ADDENDUM NO. 2 TO PROJECT NO. 47695

HVAC AND ELECTRICAL WORK
REPLACE HVAC, GARAGE
DOT REGION 10, SUFFOLK COUNTRY
375 CARLETON AVENUE
CENTRAL ISLIP, NEW YORK

February 21, 2025

M-110

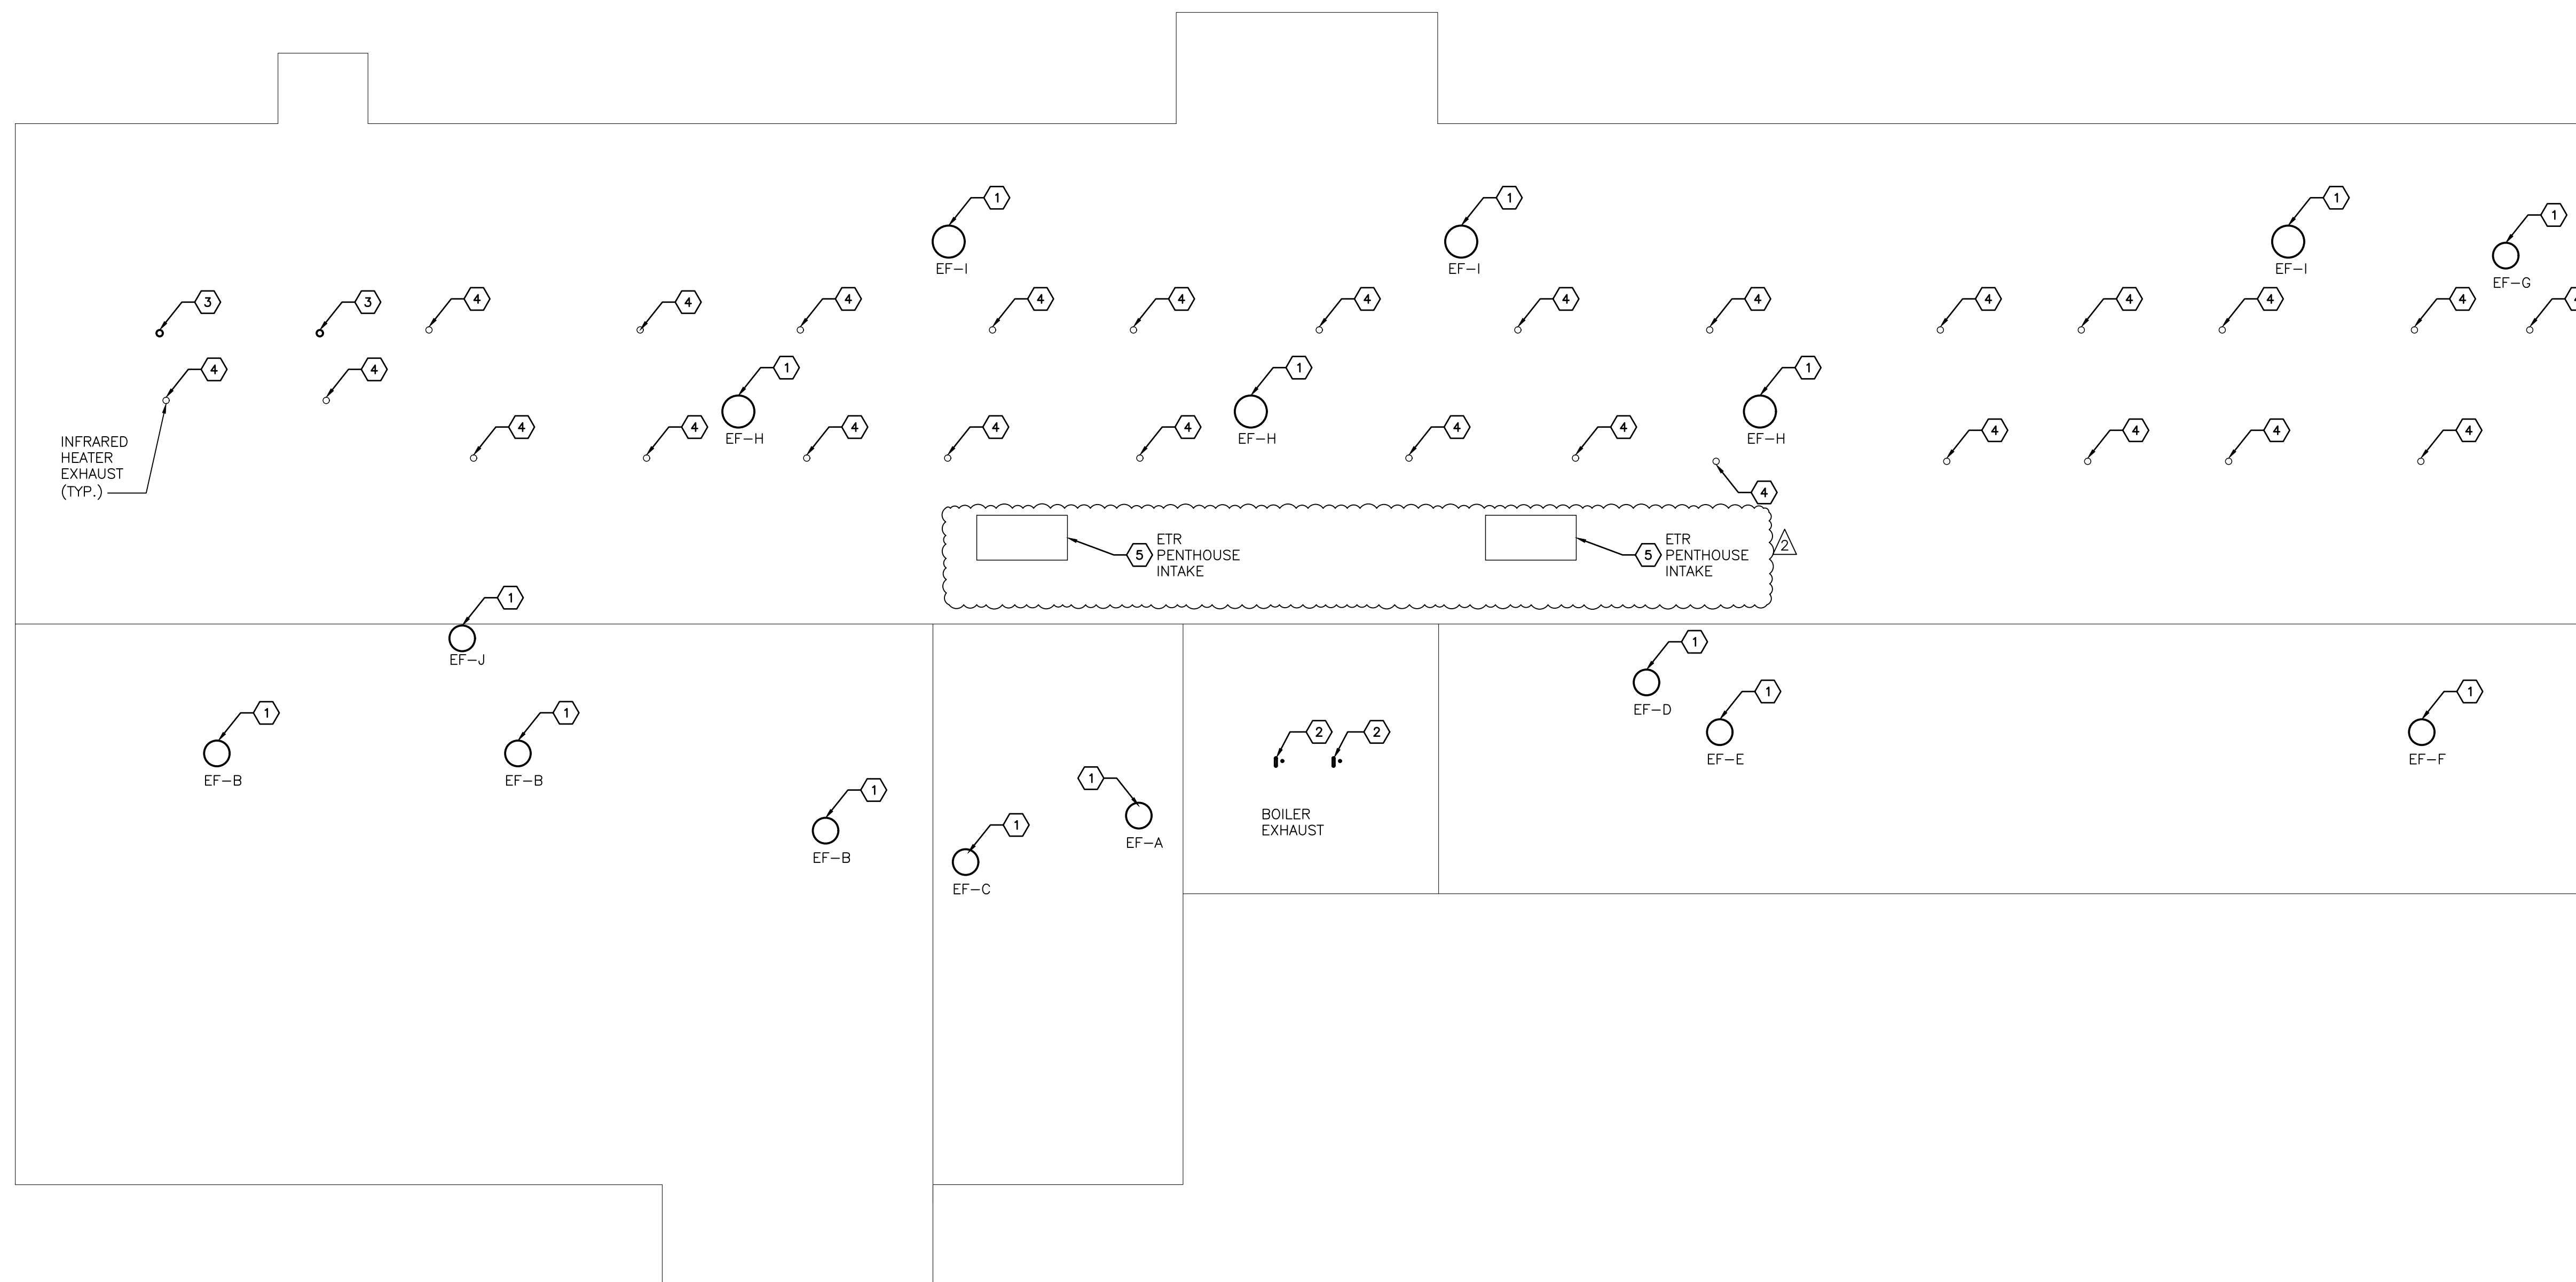
2. Revised Drawings:
 - a. Drawing No. M-105 and M-110, noted “BID ADDENDUM NO. 2 02/21/25” accompany this Addendum and supersede the same number originally issued drawings.
